Remarks/Arguments:

The attached drawing sheet includes a change to FIG. 1. This sheet replaces original drawing sheet of FIG. 1. In FIG. 1 label in box 12 has been changed from "SOIL SIDE ROBOT" to "CLEAN SIDE ROBOT."

Fig. 1

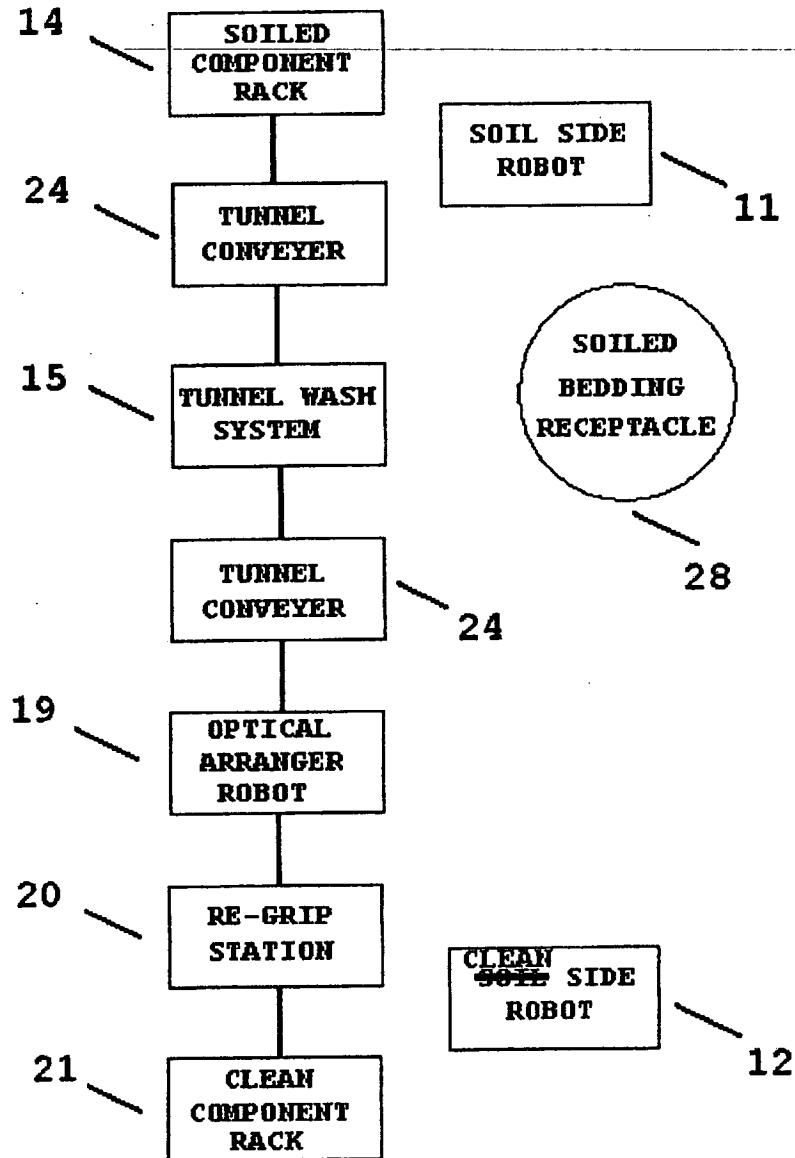
The objection to the drawings arises because the reference character "45" has been used to designate both the lower surface and the vertical coupler turret. The use of the reference character "45" on page 10, line 16 of the application is a typographical error. The reference character "45" in that line should have been "55," and the specification has been amended to correct the error. The reference character "45" only appears once in the drawings.

FIG. 1 has been amended to correct the label in box 12. The application, on page 6, lines 6 and 7, refers to box 12 as representing the clean side robot.
